SERVICE BULLETIN

EC20-021

ALTIMA WITH PR25DD ENGINE; DTC P0015 STORED

APPLIED VEHICLES: 2019-2020 Altima (L34)

Figure 1

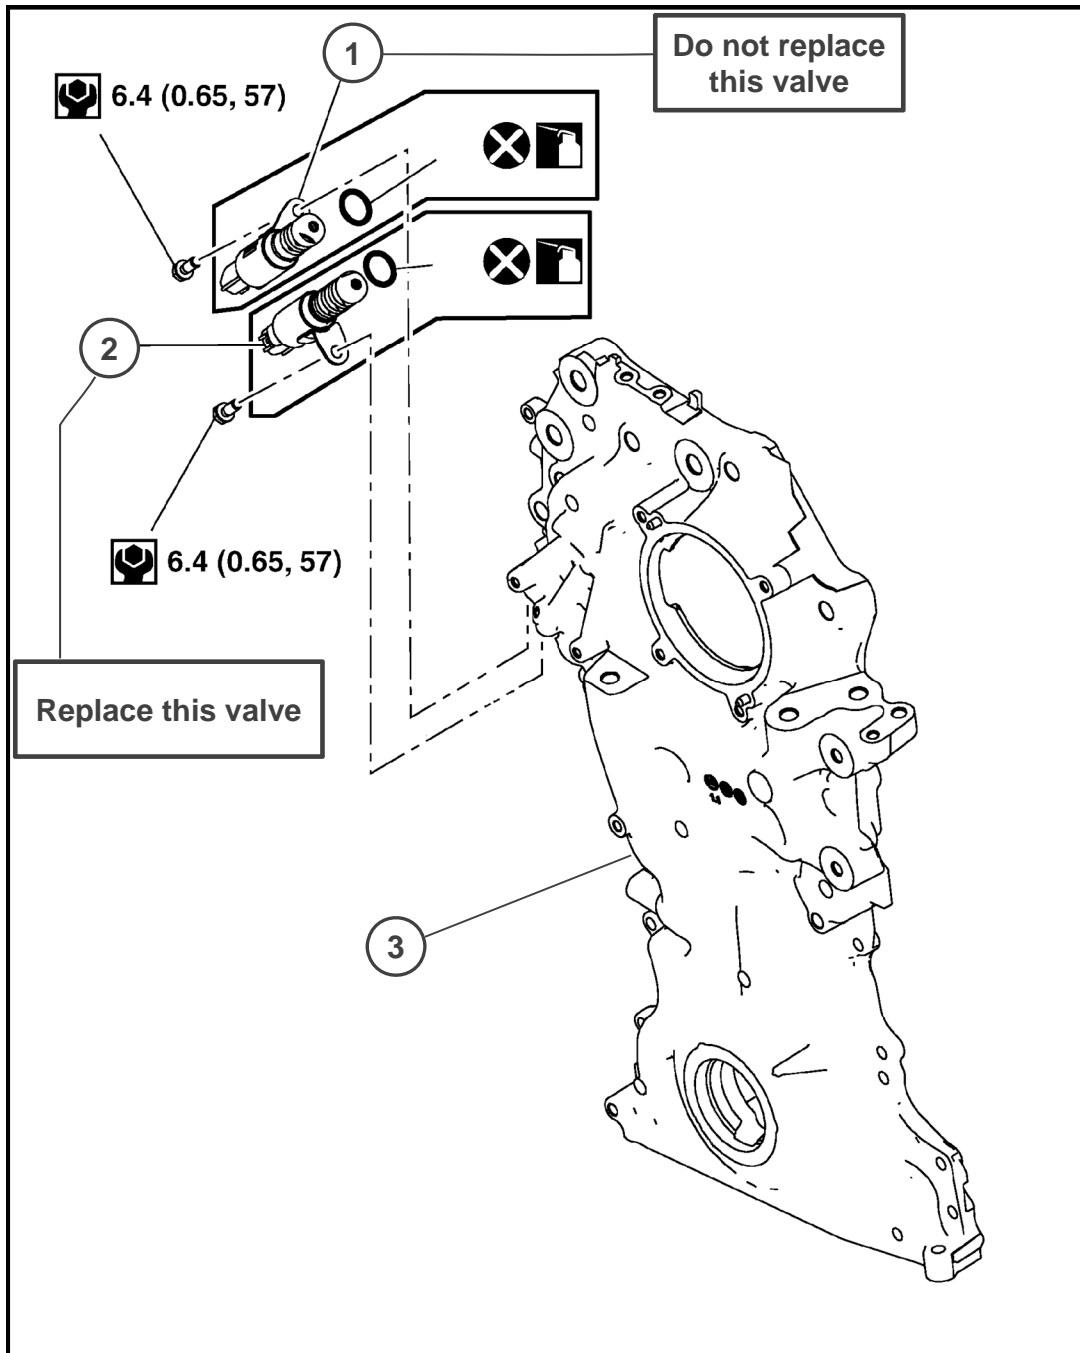
NOTE: The exploded views in the 2019 and 2020 Altima ESM may incorrectly label the exhaust valve timing control solenoid valve and the exhaust valve timing intermediate lock control solenoid valve. The exhaust valve timing control solenoid valve is positioned below the exhaust valve timing intermediate lock control solenoid valve on the front cover.

Replace the exhaust valve timing control solenoid valve.

1. Replace the exhaust valve timing control solenoid valve and O-ring.
 - Refer to the ESM, section **ENGINE > ENGINE MECHANICAL > PR25DD > REMOVAL AND INSTALLATION > SOLENOID VALVE.**
